**Re: 2021 Annual Geotechnical Inspection Report for the Doris and Madrid Sites, Hope Bay Project, Nunavut**

**Attention**      **Nancy Duquet Harvey**  
**Subject**        **Doris and Madrid - 2021 Annual Geotechnical Inspections**  
**Project**        1CT022.077

## Summary of Primary Observations and Recommendations - Table 1: Doris Project - 2021 Annual Geotechnical Inspection

**Table 1 Agnico Response to 2021 Doris AGI Recommendations**

Doris Pollution Control Pond

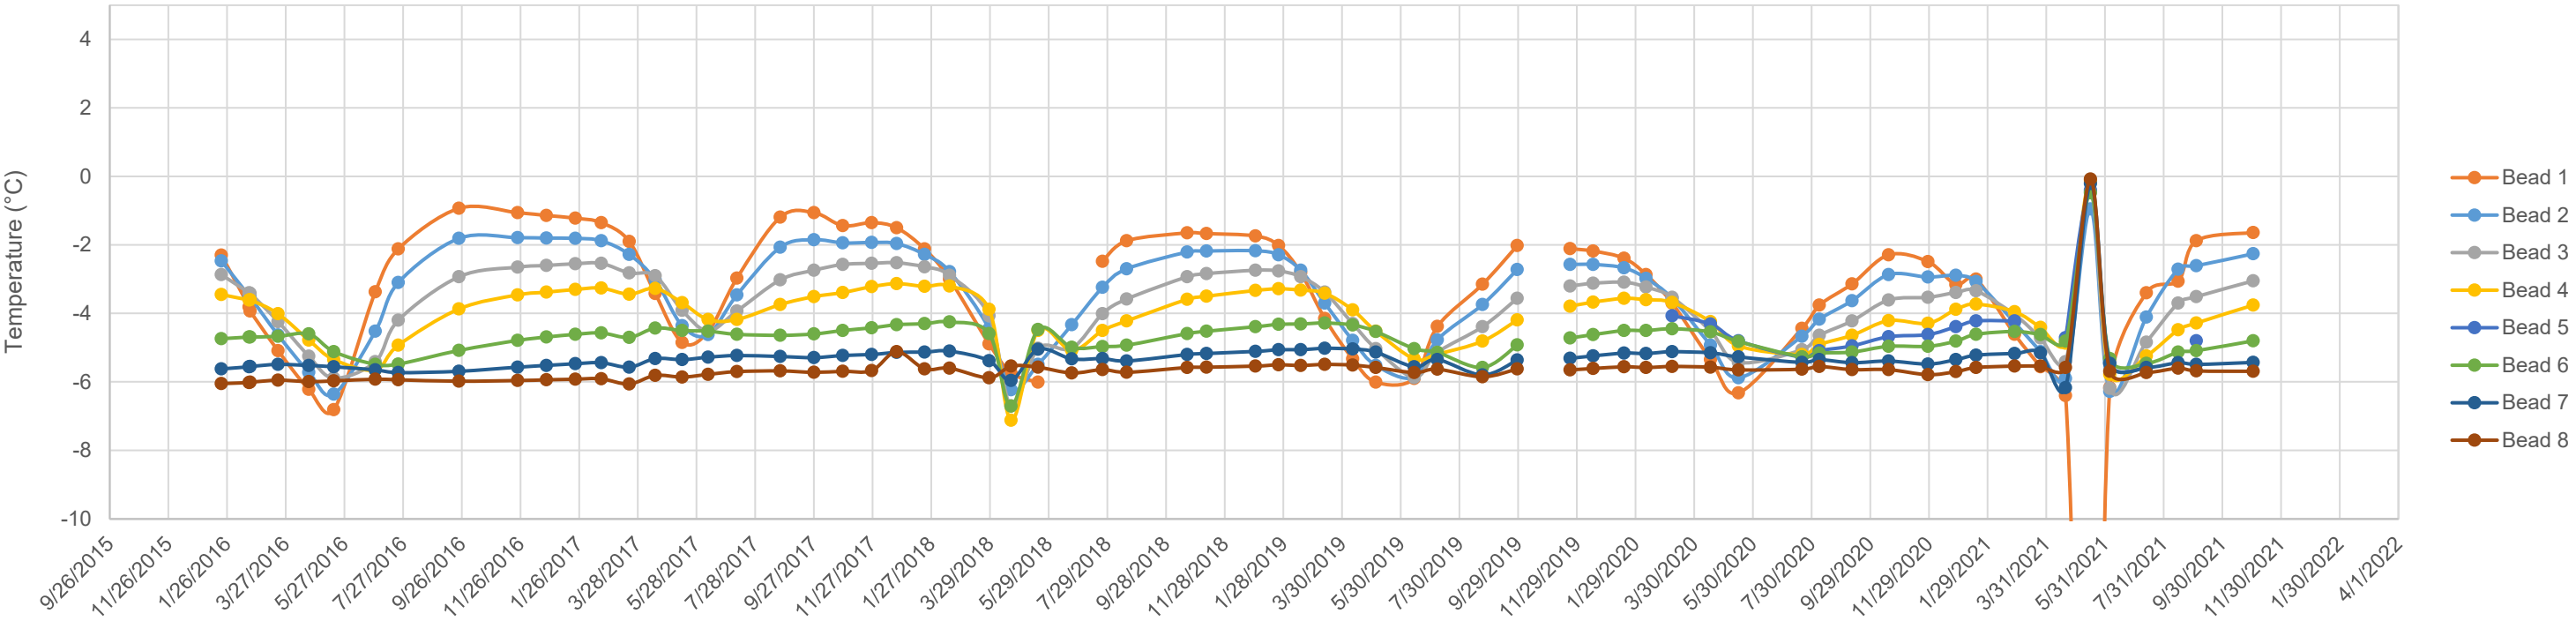
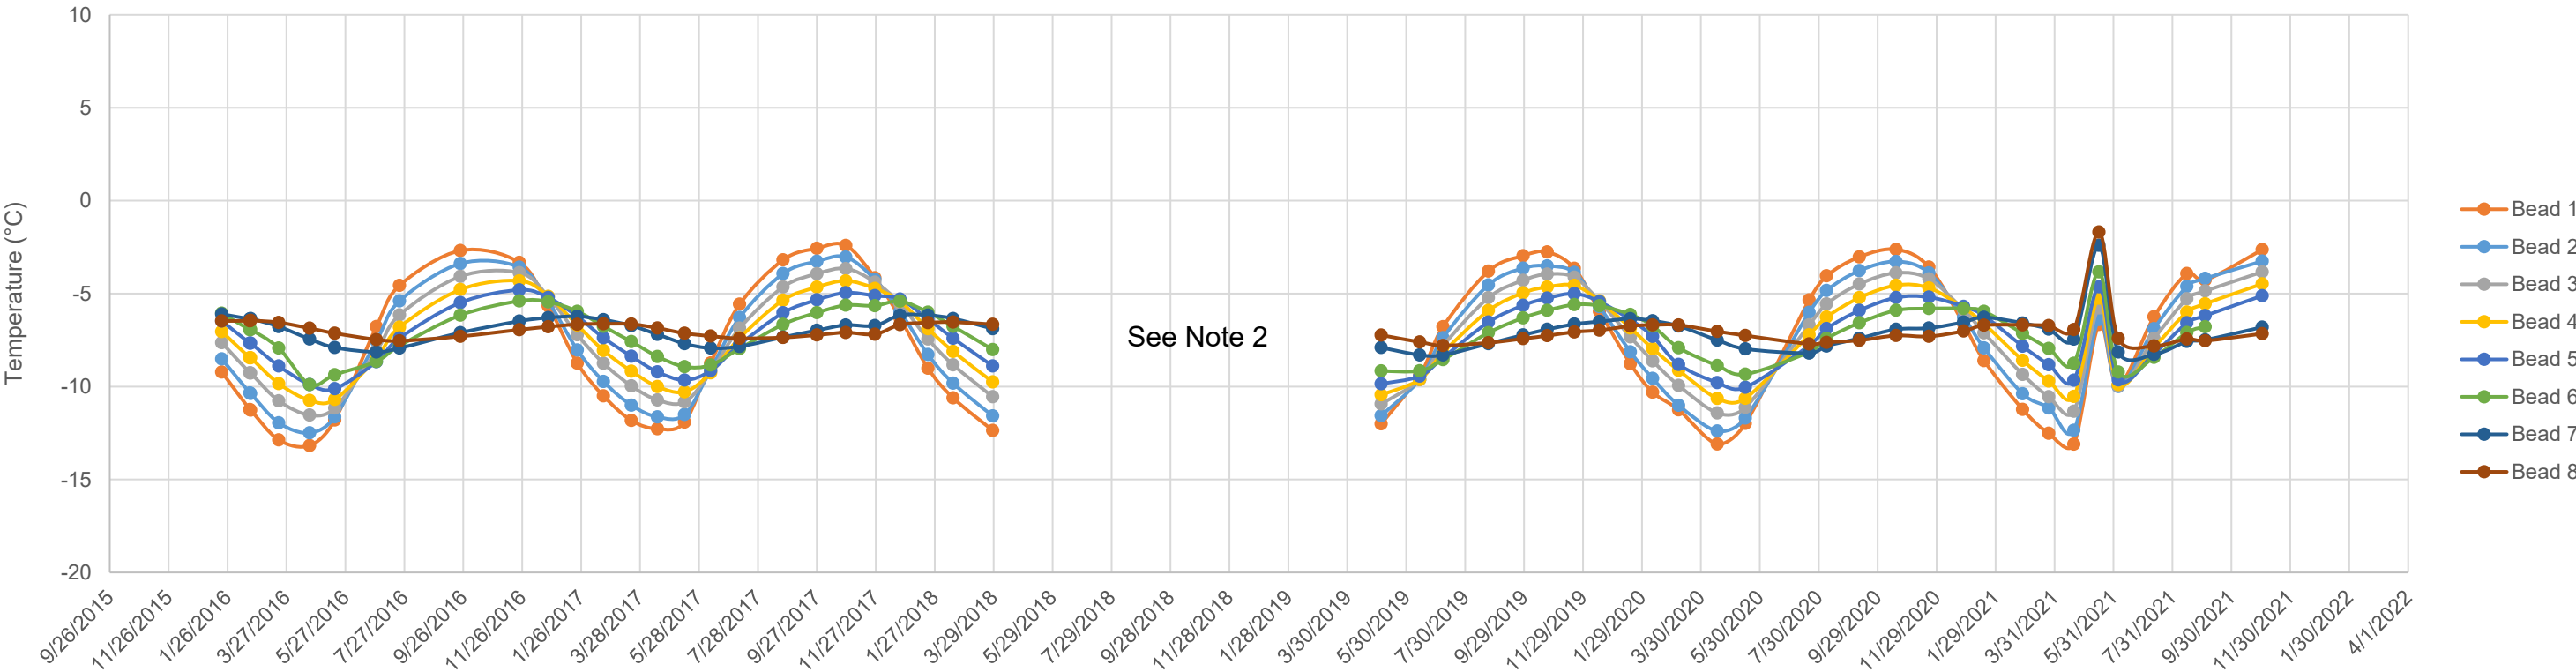
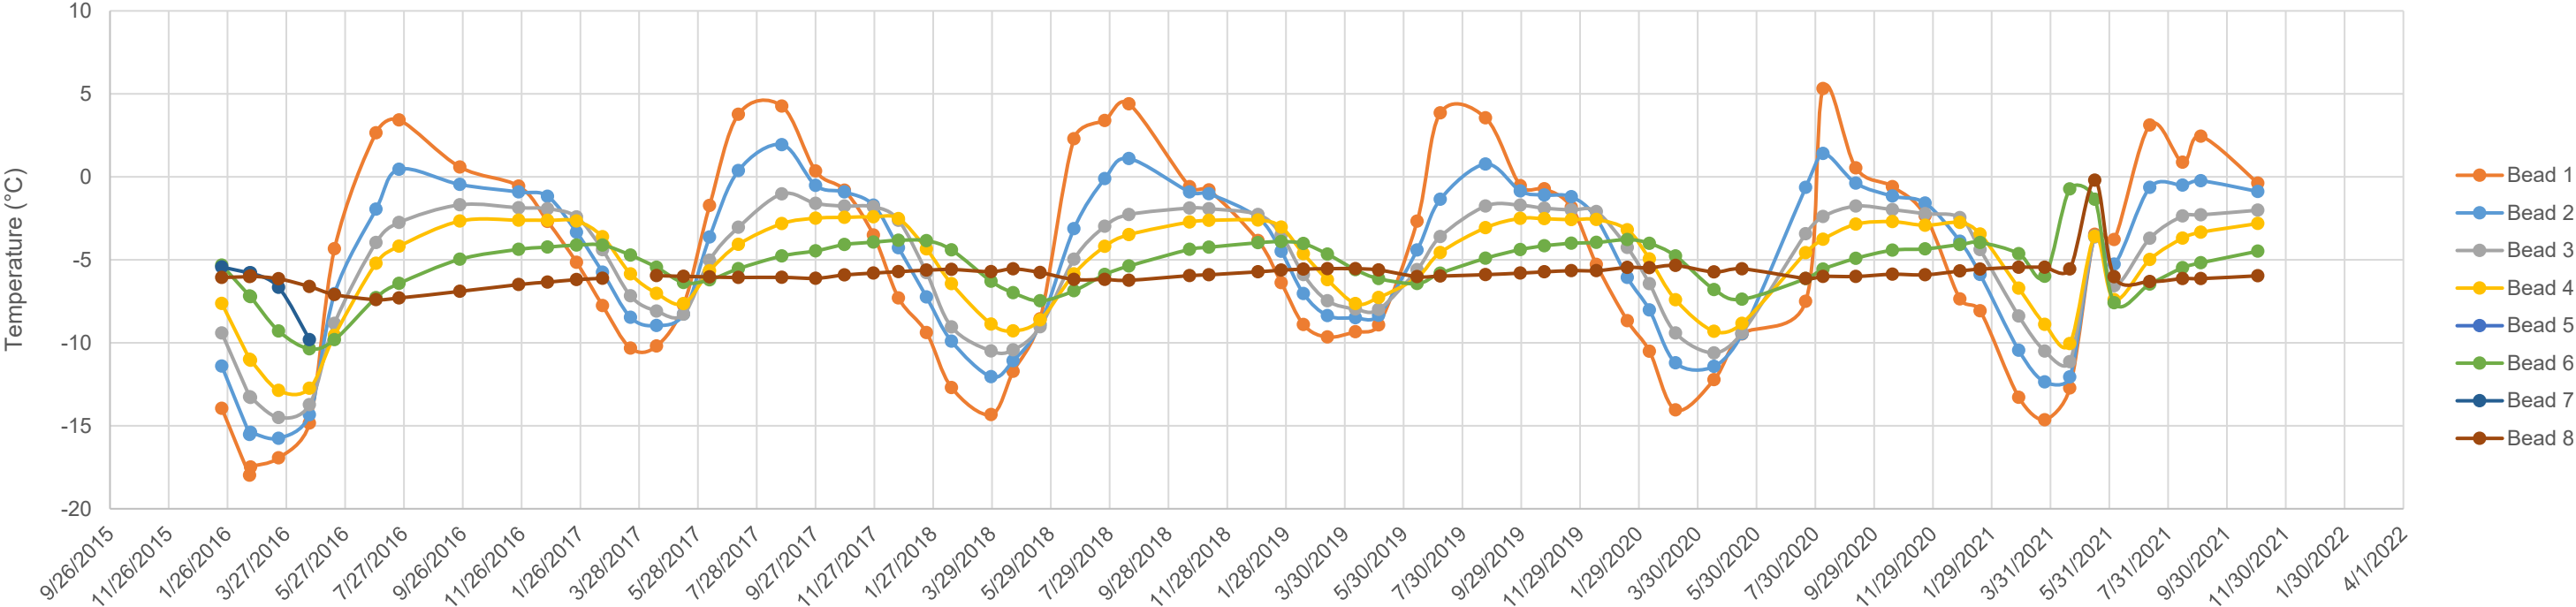
Observation	Comments and Recommendation
<p><b>POLLUTION CONTROL POND</b></p> <p>As first noted during the 2017 AGI, the Pollution Control Pond (PCP) base is very undulated because of surficial permafrost melt, and as a result there are small, ponded areas that prevent complete drainage of the pond. Site staff have now backfilled the largest depressions (with unfrozen fine-grained overburden) at the areas closest to the liner to permafrost tie-in. Coconut matting appears to also have been placed over some of the placed overburden in 2021.</p>	<p>The pollution control pond is suggested to be visually inspected by site staff on an at least bimonthly (every two months) basis over the late spring to summer months (May to August).</p> <p>Additional backfill is expected to require in the pond as part of ongoing maintenance. Additional backfill material is not immediately required but area of ponding against the liner tie-in should be avoided to reduce the risk of larger sinkholes developing and to allow for a prolonged life of the facility. At this time the main recommendation for this area is continued visual monitoring to assist in determining if or when additional unfrozen overburden backfilling may be required.</p>

Inspection Item	Recommendation	Agnico Response
Pollution Control Pond	<p>The pollution control pond is suggested to be visually inspected by site staff on an at least bimonthly (every two months) basis over the late spring to summer months (May to August).</p> <p>Additional backfill is expected to require in the pond as part of ongoing maintenance. Additional backfill material is not immediately required but area of ponding against the liner tie-in should be avoided to reduce the risk of larger sinkholes developing and to allow for a prolonged life of the facility. At this time the main recommendation for this area is continued visual monitoring to assist in determining if or when additional unfrozen overburden backfilling may be required.</p>	<p>Visual monitoring of the PCP will continue to determine if additional overburden should be placed along portions of the pond in 2022.</p> <p>Coconut matting will be placed over the overburden to reduce erosion of this material.</p>
